LA-UR-10-4921  
July 2010  
EP2010-0290

# Phase II Investigation Work Plan for Sandia Canyon

*Crosswalk of New Mexico Environment Department  
Approval with Modifications for the Sandia Canyon  
Investigation Report with the Phase II Investigation Work Plan  
for Sandia Canyon*

**Figure 4.1-1** Aerial view of the upper Sandia Canyon wetlands showing the trace of the Rendija Canyon fault (hatched red line) and the proposed DC-resistivity lines (red, olive green, and blue lines)

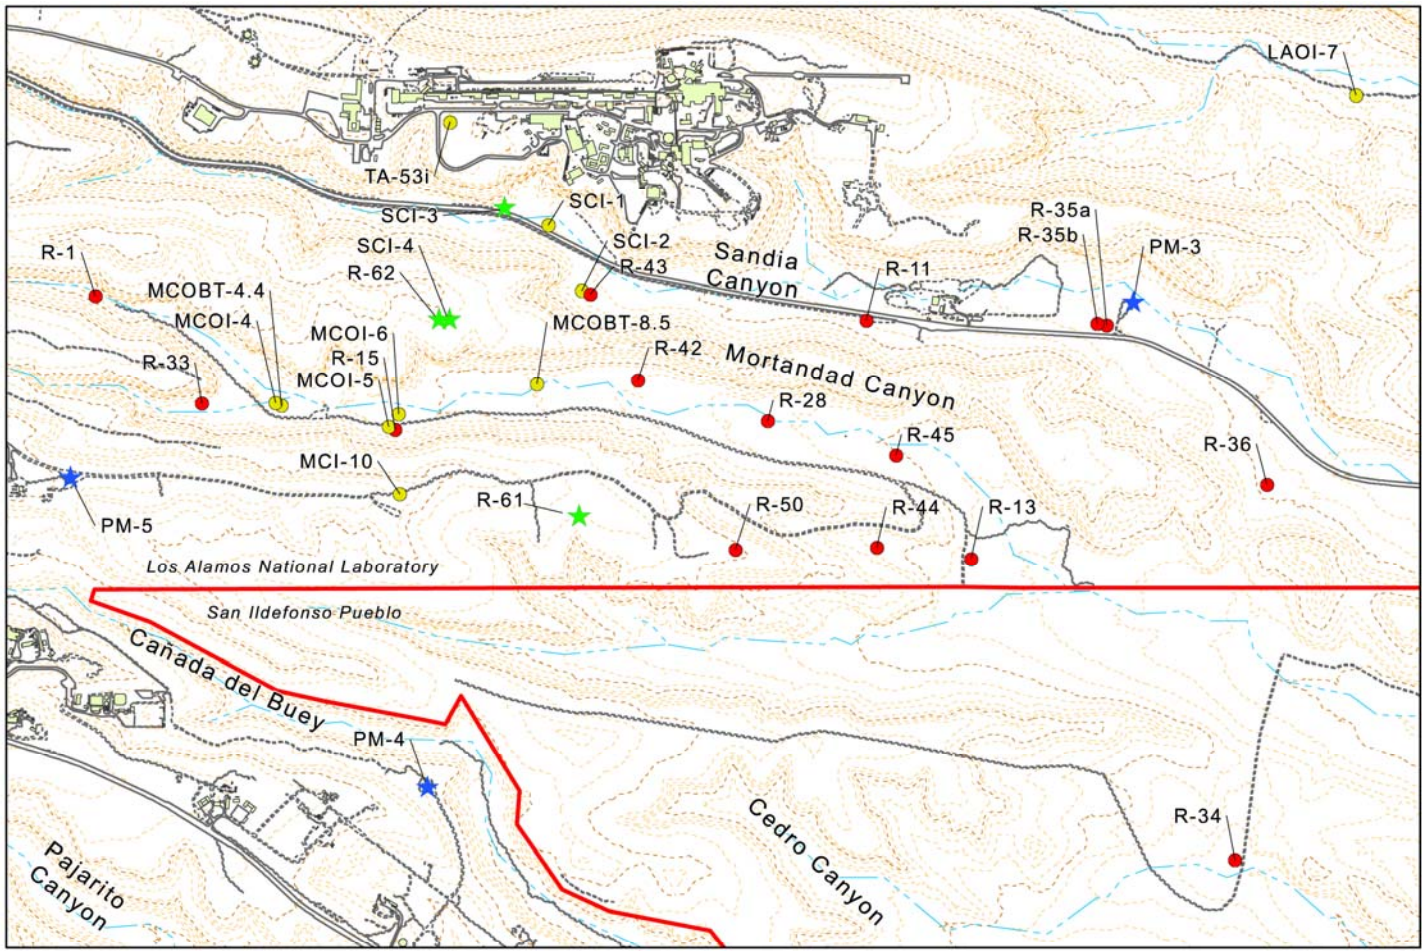
NMED Comment No.	Summary of NMED Comment and Requirement	LANL Proposed Action	Rationale for Proposed Action if Different from NMED Requirement
8	<p>LANL must conduct a surface-based direct current– (DC-) resistivity geophysical survey in the vicinity of the Sandia Canyon wetland and use the survey results to identify the most likely area of infiltration beneath the wetlands. In addition, LANL must drill a core hole to 200 ft depth and characterize the core for moisture, anions, cations, and COPCs.</p>	<p>LANL will conduct a surface-based DC-resistivity geophysical survey in the vicinity of the Sandia Canyon wetland, as discussed in section 4.1 of this work plan. The geophysical results will be used to decide whether and where a core hole is needed to define the vertical extent of contamination.</p>	<p>As discussed with NMED at a meeting on June 3, 2010, surface-water balance studies presented in three previous chromium-related reports indicate infiltration beneath the wetland is minimal (LANL 2006, 094431; LANL 2007, 098938; LANL 2008, 102996). If the geophysical survey corroborates the water-balance data, a core hole will not need to be drilled to define the vertical extent of contamination. A core hole will be drilled if the geophysical results suggest there are areas of focused infiltration.</p>

Rendija Canyon fault, shown in cross-hatched pattern in Figure 4.1-1. Detailed mapping of fault traces north and south of the wetland for the Laboratory's Seismic Hazards Program reveals that the fault forms a broad zone of deformation that contains multiple, lesser fault splays trending northeast-southwest across the wetland. To examine the subsurface for evidence of infiltration in bedrock and along fault splays, a set of at least three subparallel DC-resistivity profiles is proposed, as shown in the red, olive green, and blue lines in Figure 4.1-1.

The total length of three resistivity profiles as shown in Figure 4.1-1 is approximately 5000 ft. With 20-ft probe spacing along each line, this amounts to the use of approximately 250 DC-resistivity probes, a number well within the scope of previous DC-resistivity profiling in canyons at the Laboratory. The practical depth of interrogation will be approximately 300 ft, sufficient to see well into bedrock beneath alluvial fill.

Figure 4.3-1 New sediment investigation reach S-5EC in Sandia Canyon

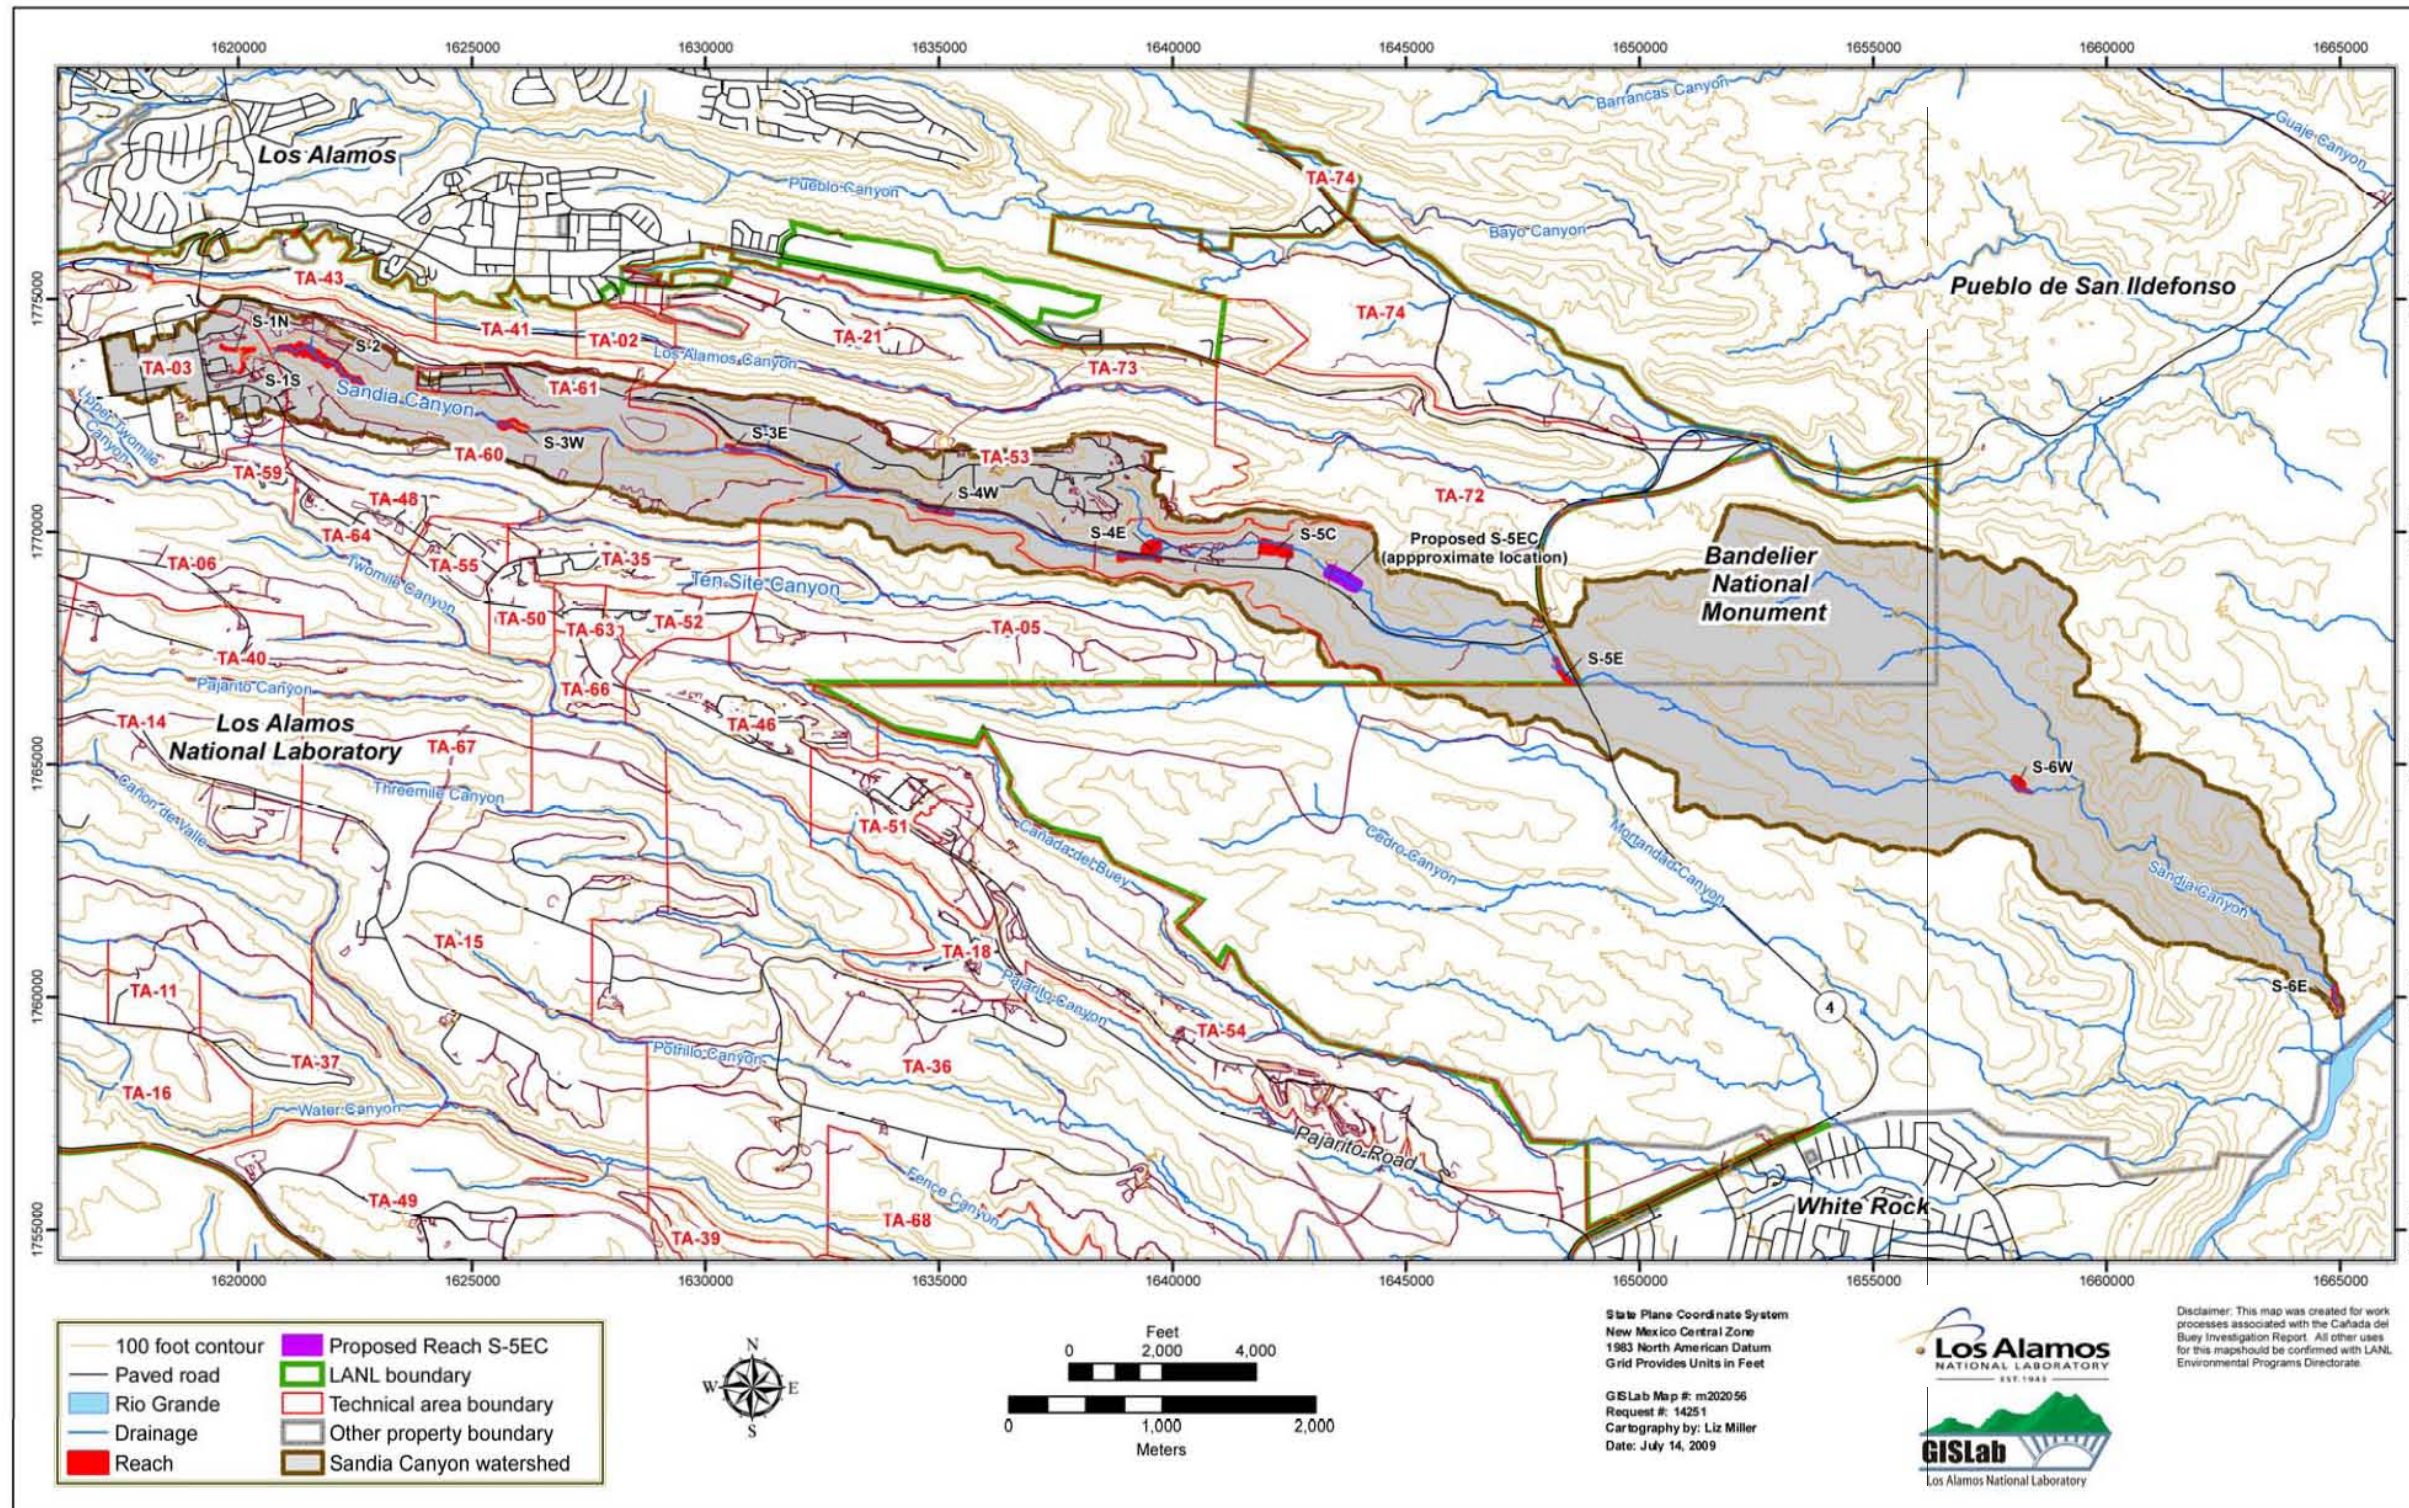
NMED Comment No.	Summary of NMED Comment and Requirement	LANL Proposed Action	Rationale for Proposed Action if Different from NMED Requirement
11	<p>A large alluvial fan deposit located 2000 ft east of PM-3 may have caused damming of floodwaters on the canyon floor and deposition of sediments onto the adjacent floodplain. These deposits were not investigated during the Sandia Canyon investigation.</p> <p>LANL must collect surface and subsurface sediment samples from these deposits and analyze the samples for a full suite of inorganic and organic compounds. The results must be reported in the Phase II investigation report.</p>	<p>An additional sediment investigation reach will be added in the area of Sandia Canyon east of PM-3, including the area of maximum sediment deposition. These data will be used to better define the nature and extent of chromium contamination in surface sediments.</p> <p>Ten sediment samples, including both surface and subsurface samples, will be collected in this reach and analyzed for the full suite of inorganic and organic chemicals that have been identified as COPCs in the adjacent reaches (reaches S-5C and S-5E), as described in section 4.3. The results of this investigation will be used to revise the conceptual model of contaminant distribution and inventory, as necessary. The new reach data will also be evaluated in the context of potential human health risk, if required. Results will be presented in the Phase II investigation report.</p>	n/a

Sediment data will be collected in a new reach in Sandia Canyon east of reach S-5C and well PM-3 to better define the nature and extent of chromium contamination in surface sediments. The new reach contains a large sediment deposition area where a single defined stream channel is replaced by a broad canyon-bottom fan. The new reach, designated S-5EC (S-5 East-Central), will be at least 600 ft long and will encompass the sediment deposition area (Figure 4.3-1). These new sediment data are being collected to define the sediment thickness, volume, and contaminant inventory in a poorly characterized area, and they will be used to revise the conceptual model of contaminant distribution and inventory, as necessary. The new reach data will also be evaluated in the context of potential human health risk, if required.

Post-1942 geomorphic units will be mapped in this reach at a scale of 1:200, and sediment thicknesses and characteristics in each unit will be determined in a series of hand-dug holes. If the post-1942 sediment is too thick to be examined in hand-dug holes (>4 ft), auger holes will supplement the hand-dug holes. Ten sediment samples will be collected in this reach, including both surface and subsurface layers and a range in particle sizes. These samples will be analyzed for the full suite of inorganic and organic COPCs identified in the adjacent reaches (S-5C and S-5E) (LANL 2009, 107453). This chemical suite will include target analyte list metals, molybdenum, perchlorate, pesticides, polychlorinated biphenyls, polycyclic aromatic hydrocarbons, semivolatile organic compounds, total petroleum hydrocarbons–diesel range organics, and volatile organic compounds.

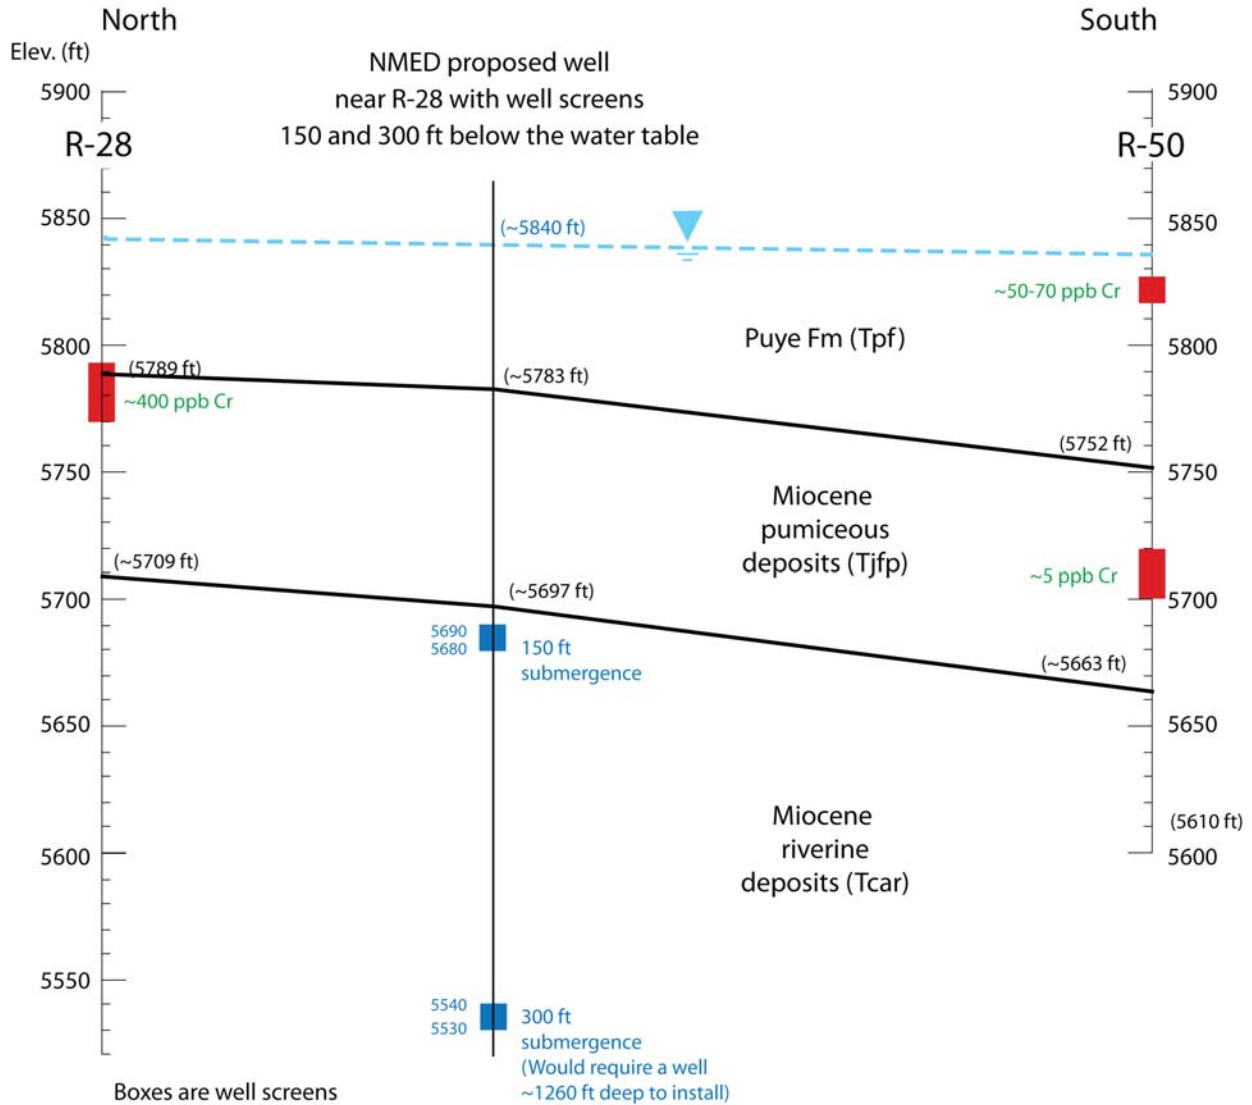
NMED Comment No.	Summary of NMED Comment and Requirement	LANL Proposed Action	Rationale for Proposed Action if Different from NMED Requirement
3	<p>The vertical and western extents of the chromium plume in the regional aquifer are not adequately defined.</p> <p>LANL will install a dual-screen well at depths of 150 and 300 ft below the water table in the regional aquifer at well R-28 to define the vertical extent of contamination and will also install a second dual-screen well west of well R-42 on the mesa separating Sandia and Mortandad Canyons.</p>	<p>Two regional aquifer wells are proposed in this work plan (section 4.2). The well locations are shown in Figure 4.2-1.</p> <p>The location for well R-61 has been changed from the original NMED requirement to define the vertical extent of contamination near well R 28. The new proposed location and dual-screen design for well R-61 reduce uncertainty about the nature and extent of chromium contamination in light of recent observed chromium concentrations detected at newly installed well R-50, and they help to delineate the vertical extent of chromium contamination at that location.</p> <p>A second dual screen well, R-62, will be installed west of well R-42 on the mesa separating Sandia and Mortandad Canyons, in accordance with NMED's requirement.</p>	<p>Recent data from newly installed well R-50 shows that chromium is present at or above regulatory standards in the upper part of the regional aquifer near the LANL boundary with San Ildefonso Pueblo, potentially indicating a southerly component of groundwater flow different from that predicted by groundwater gradients alone or possibly additional breakthrough points or sources of chromium. As discussed with NMED at a meeting on June 3, 2010, these new results highlight important uncertainties about conceptual models for chromium migration. These uncertainties are discussed in section 3 of this work plan. Monitoring data from existing dual-screen wells, including R-50, provide good evidence that chromium migration occurs in the upper part of the aquifer and that the vertical extent of chromium is sufficiently constrained by the existing network of wells (see Figures A-1 and A-2).</p> <p>The proposed well R-61 will further define the nature and extent of chromium contamination south of well R-42 by installing a dual-screen well that monitors groundwater at the water table and approximately 100 ft below the water table. The proposed location for well R-61 will provide key information about contaminant distributions and water chemistry that will be important for evaluating the conceptual model uncertainties for the chromium infiltration pathway, migration within the regional aquifer, and a potential additional source, as discussed in section 3.</p>
